ART SELECTION ADVISORY COMMITTEE
Friday, August 10, 2012 1:00 PM – 3:00 PM
City of Fairbanks, City Hall, 800 Cushman Street
FMATS Conference Room

FMATS Art Selection Advisory Committee
Meeting Summary
July 24, 2012
Fairbanks City Hall, City Council Chambers

Fairbanks Downtown Greenspace Project
RFQ/C Questions and Answers
August 13, 2012

1 TRIANGLE PARK PLANTING PLAN
8.06D

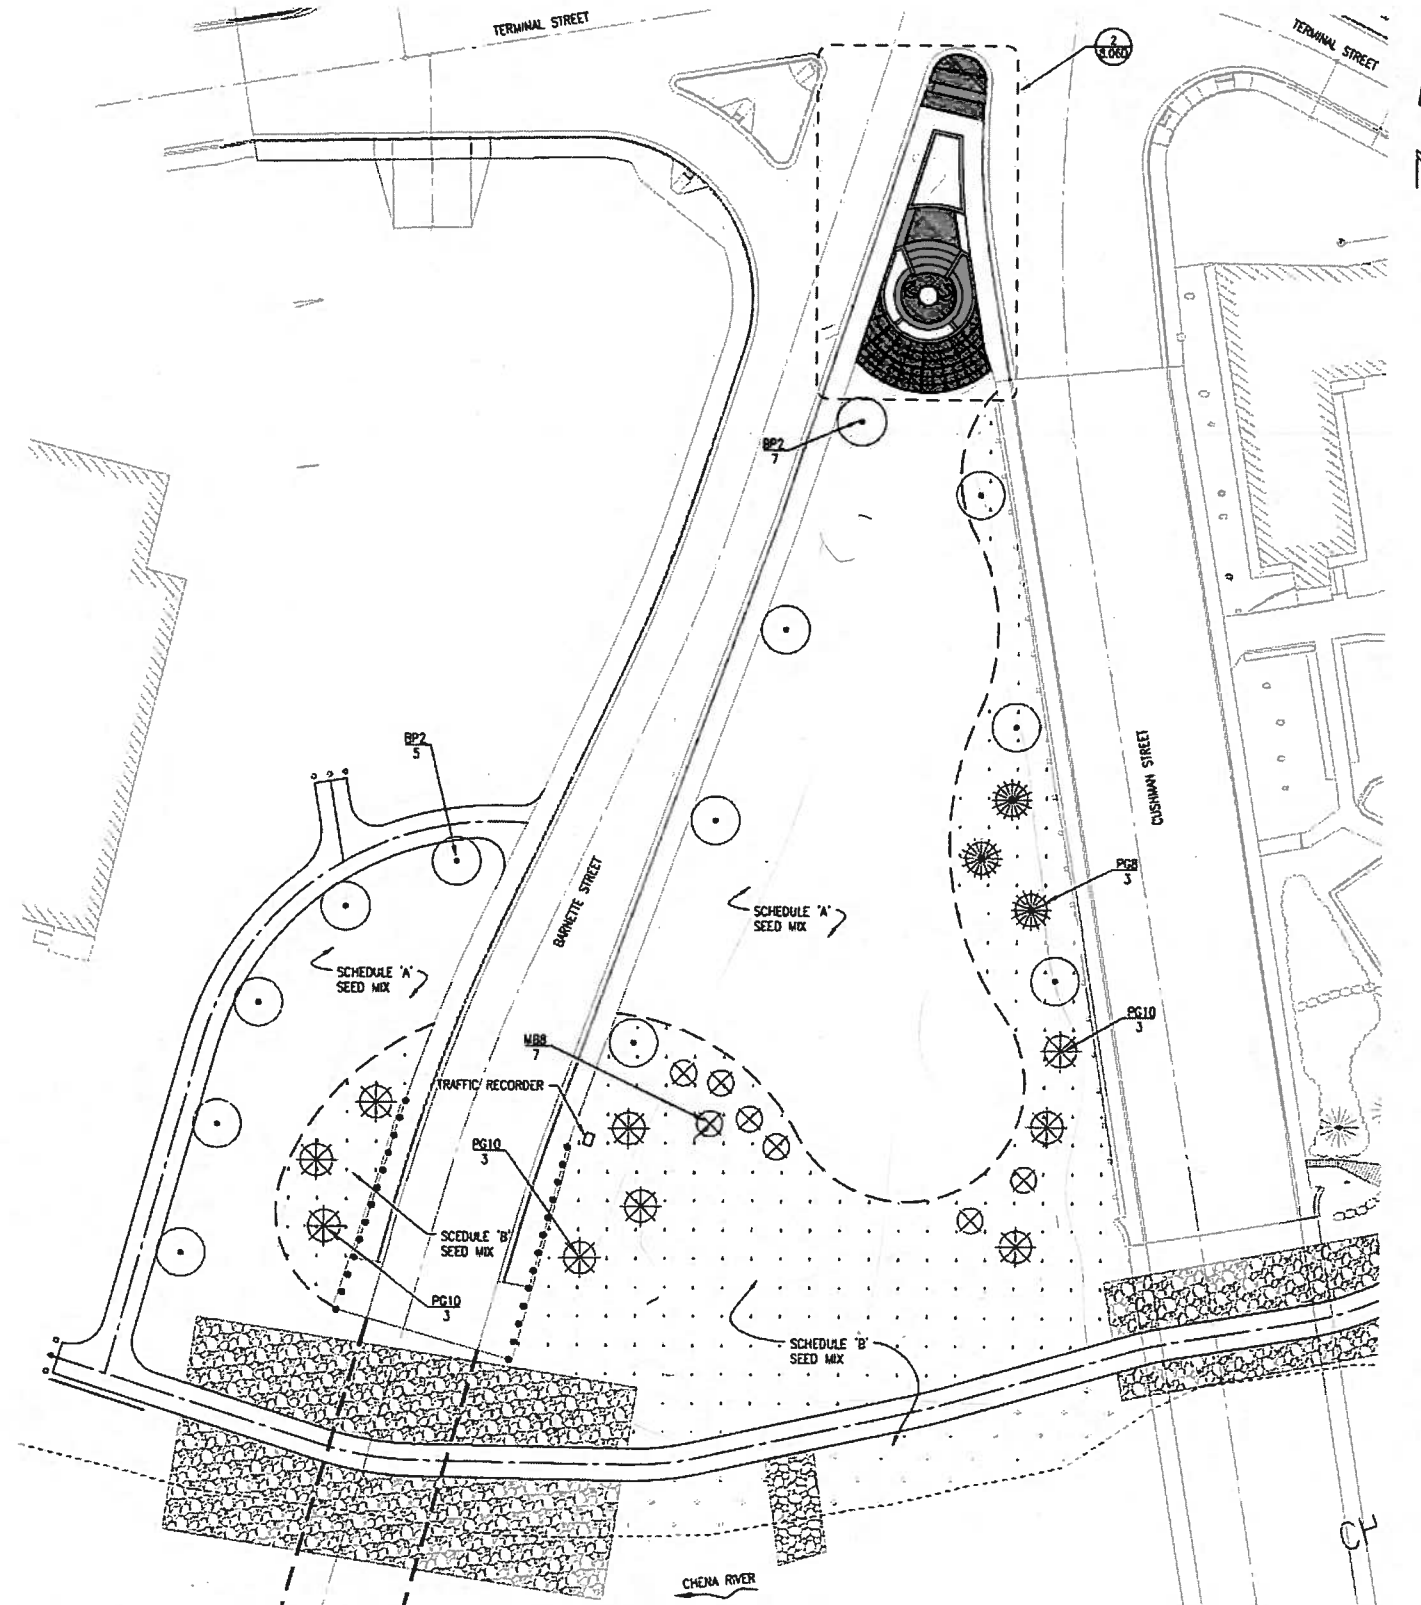
2. Has the site landscaping phase of the project been completed or is final grading awaiting the artist proposal?

13. Does the project include associated landscaping?

31. Will you consider submissions which alter the landscape proposed on page 1 of the site details attachment? If so, are there limitations in what can be altered (i.e. grading, planting or incorporating/altering the proposed plaza on the northern end of the greenway)?

34. Because the greenspace is not yet fully constructed, is there any possibility to change or amend the construction of the greenspace to accommodate or enhance the art within that contract?

The final grading design has been completed. See the greenspace landscaping PDF (attached). Any grading changes proposed will need to be reviewed and approved by the State of Alaska Department of Transportation and Public Facilities (DOT & PF).

The artist will need to be able to work around those plantings shown in the greenspace landscaping pdf (attached). The project can include additional landscaping but maintenance will be a consideration under all circumstances.

Yes, the committee will consider submissions that alter the landscape within limits. The final grading design has been completed. See the greenspace landscaping PDF (attached). Any grading changes proposed will need to be reviewed and approved by the DOT & PF. The plaza cannot be altered.

The final grading design has been completed. See the greenspace landscaping PDF (attached). Any grading changes proposed will need to be reviewed and approved by the State of Alaska Department of Transportation and Public Facilities (DOT & PF) and will be a part of the artist's budget for the work.

1 ILLINOIS-CUSHMAN STREETS VICINITY MAP AND KEY PLAN
8.01D

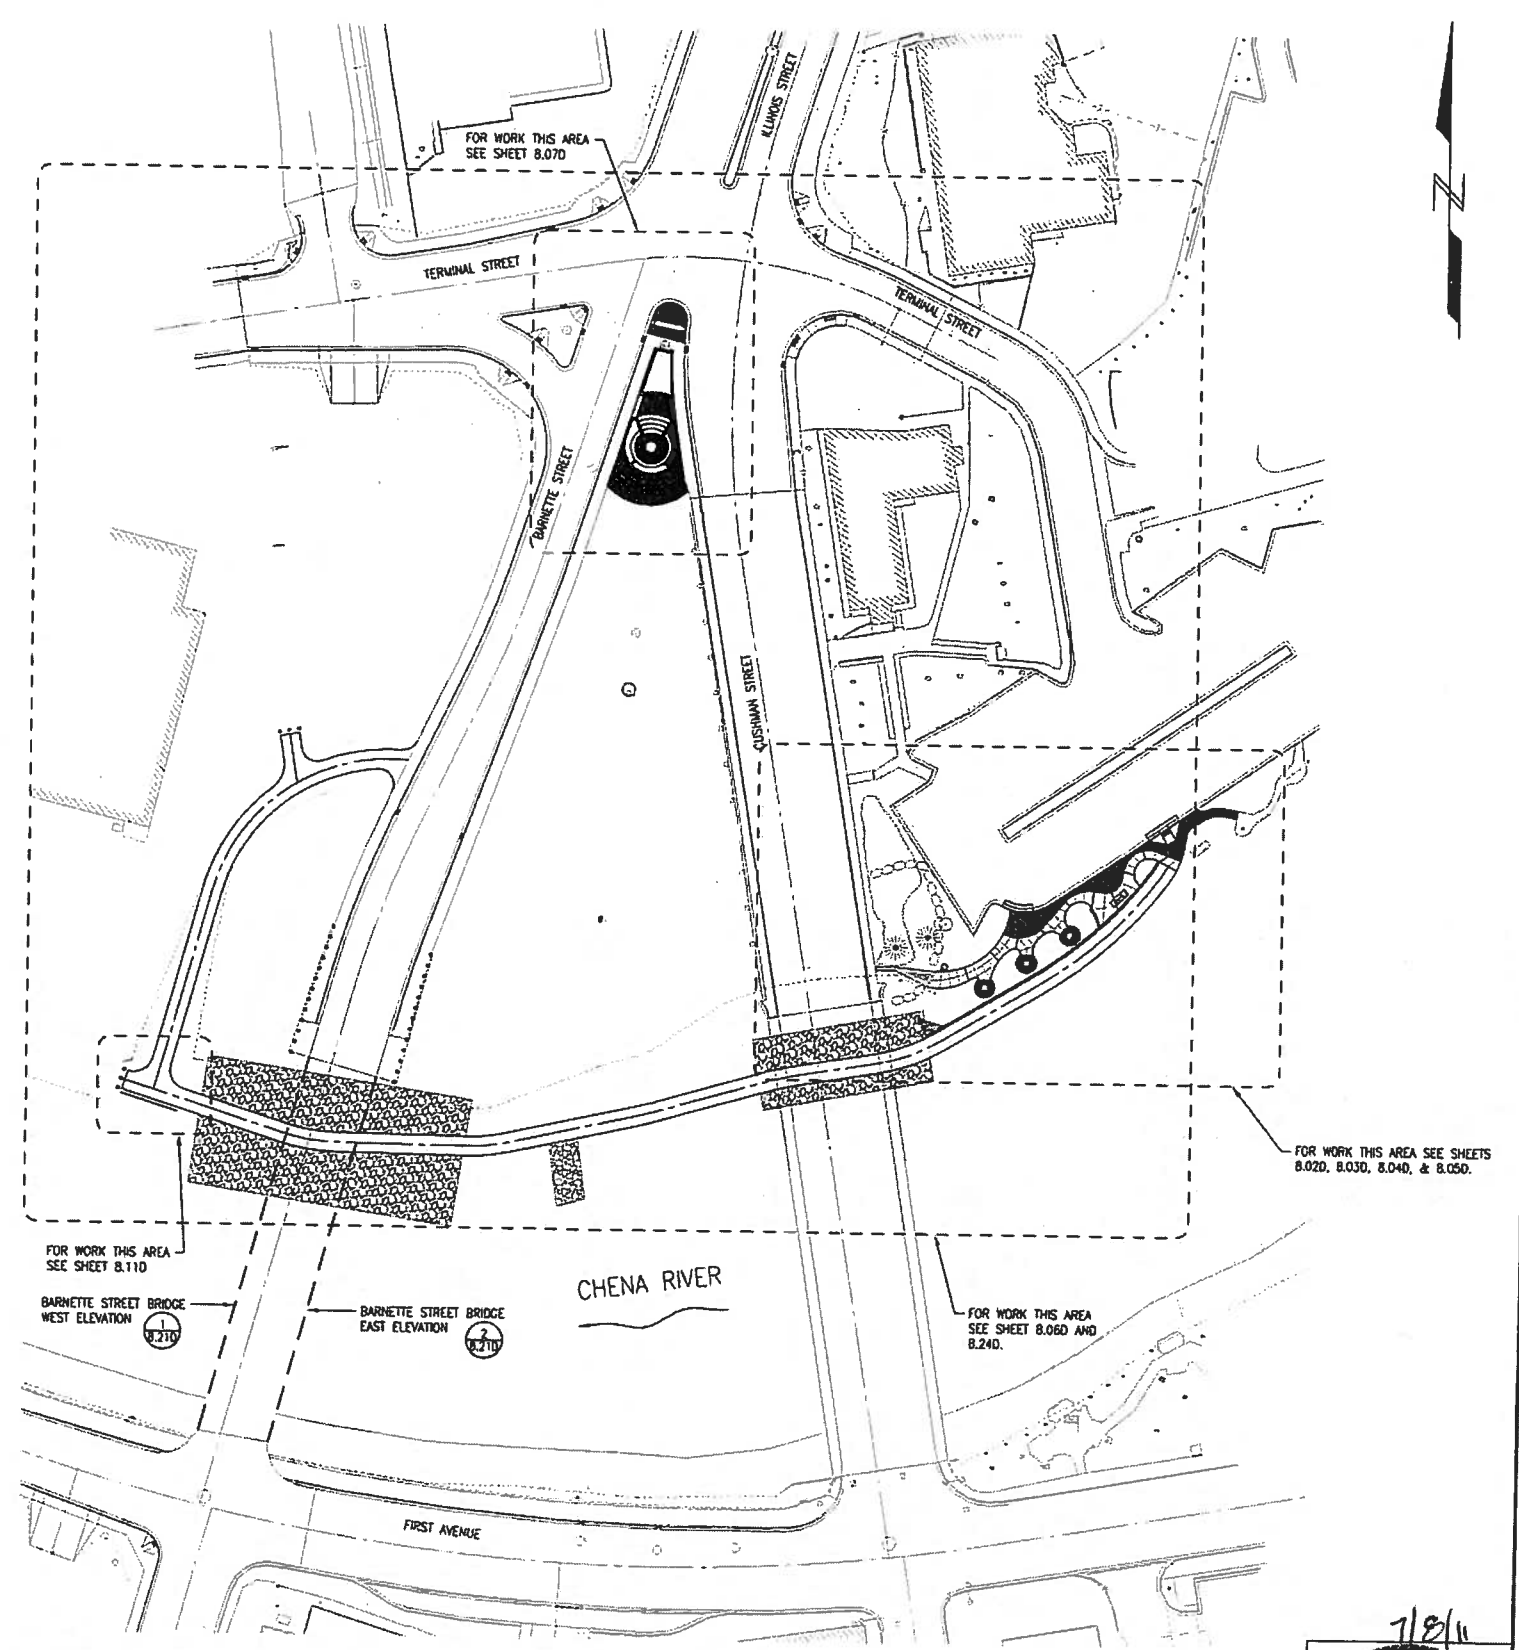
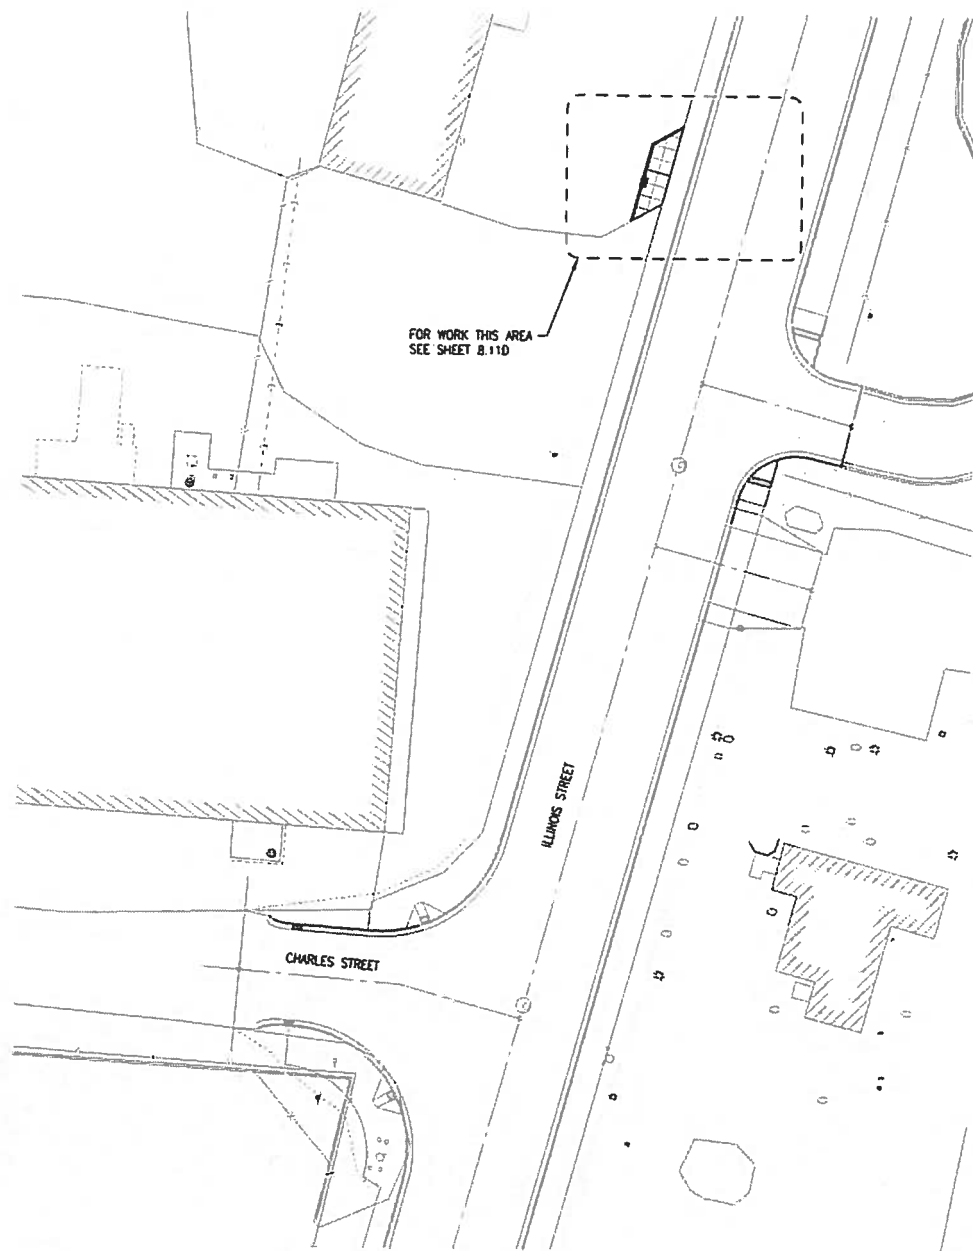
3. When does the river trail get completed and is there a map of its route?

See the streetscape key plan (attached) for bike path details. The bike path will be complete this September. It connects to Barnette Street approximately 225' north of the bridge. It comes down west of Barnette Street next to the warehouse and goes underneath the Barnette Street and Cushman Street bridges and ends approximately 175' east of the Cushman Street Bridge in Shoreway/Overlook Park.
